**SUBMITTAL TO THE BOARD OF SUPERVISORS  
COUNTY OF RIVERSIDE, STATE OF CALIFORNIA**

**SUBJECT:** FACILITIES MANAGEMENT (FM): Lakeland Village Sports Park - Approval of Change Order No. 3 and Notice of Completion with Roadway Engineering & Construction Corp.; District 2. [\$583,487 - 100% American Rescue Plan Act (ARPA) Fund (Previously approved budget)] (Clerk to Record Notice of Completion)

**CHANGE ORDER NO. 3** to Riverside County Clerk of the Board, Stop 1010  
 Post Office Box 1147, Riverside, Ca 92502-1147

Project Name: Lakeland Village Sports Park

**LANDSCAPE CONSTRUCTION PLAN**

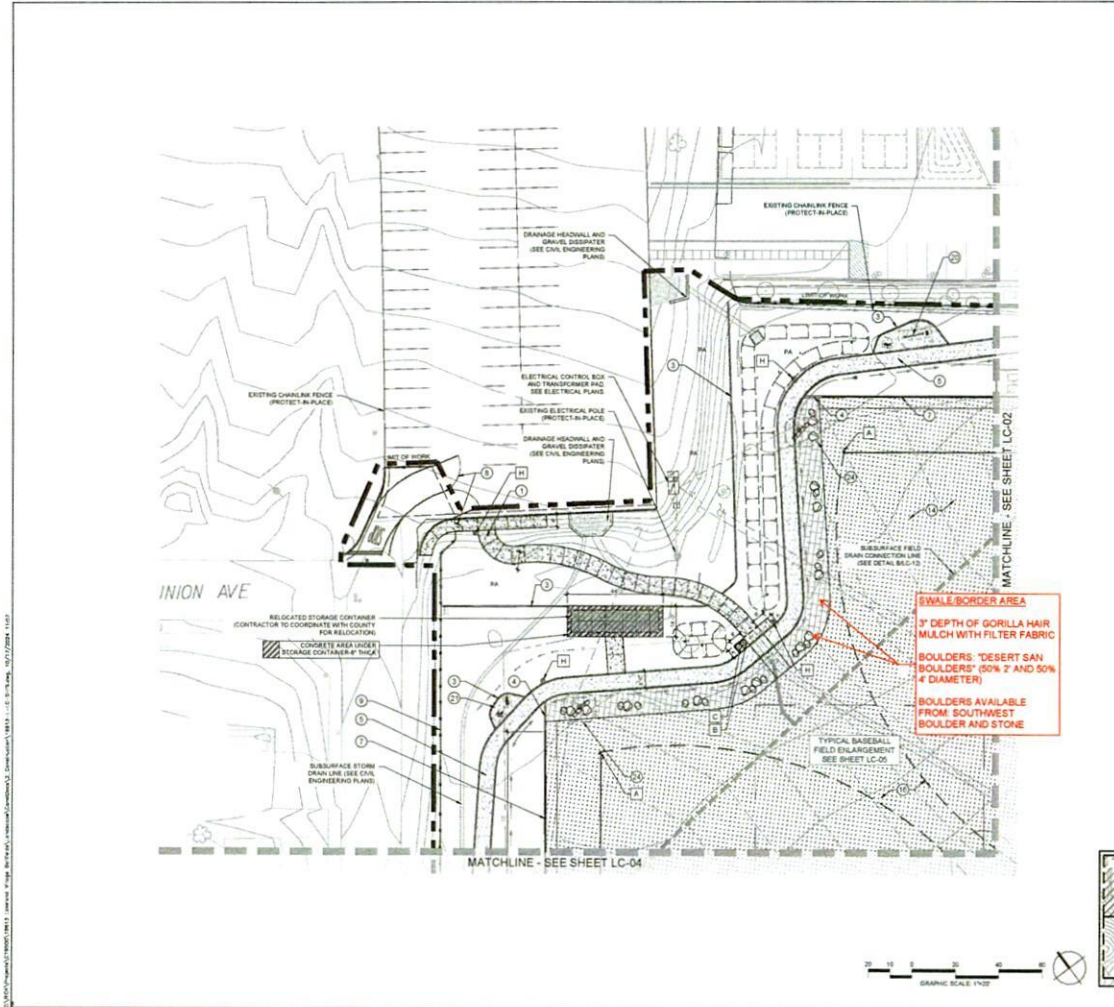
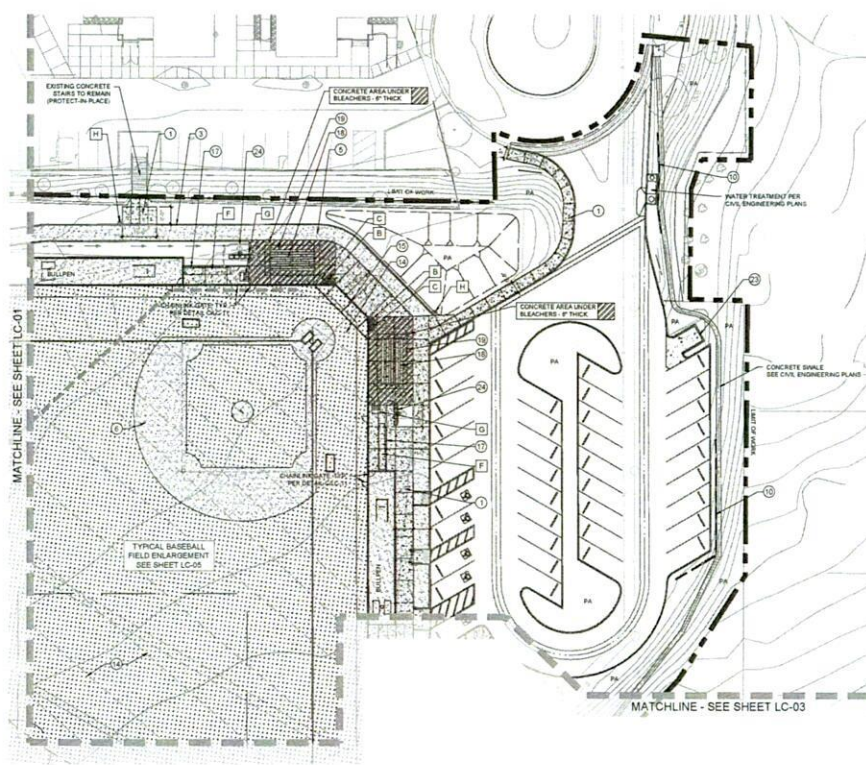
1. Remove Salvia from the hillside near the lower parking lot
2. Reduce the boulders by half
